PRODUCT UPDATE

PU-08-008

Product Update **Hendrickson** **INTRAAX with ZMD Technology**

LIT NO: P26014 Rev: A
DATE: May 2017

PRODUCT UPDATE INTRAAX® with ZMD® Technology

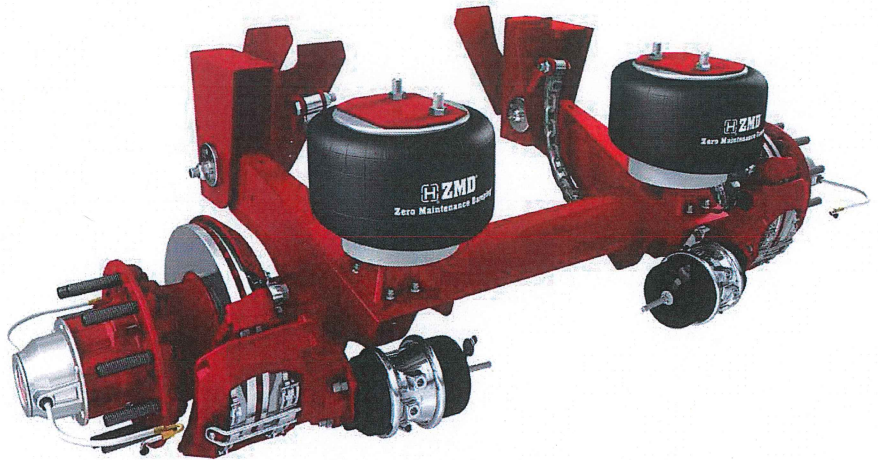
Hendrickson Trailer Commercial Vehicle Systems is pleased to announce the availability of additional ride heights on ZMD® ZERO MAINTENANCE DAMPING® technology for INTRAAX® AANT 23K integrated suspension systems. Previously only available for 14-inch ride heights, ZMD can now be specified for AANT 23K models with 15-inch through 17-inch ride heights with standard travel.

ZMD ride technology can be specified on new, or retrofitted on existing, INTRAAX AANT 23K 14-inch through 17-inch ride height models with standard travel. Retrofit installation is easy and efficient as ZMD components fit the existing INTRAAX air spring and shock mount structures and use the same mounting hardware.
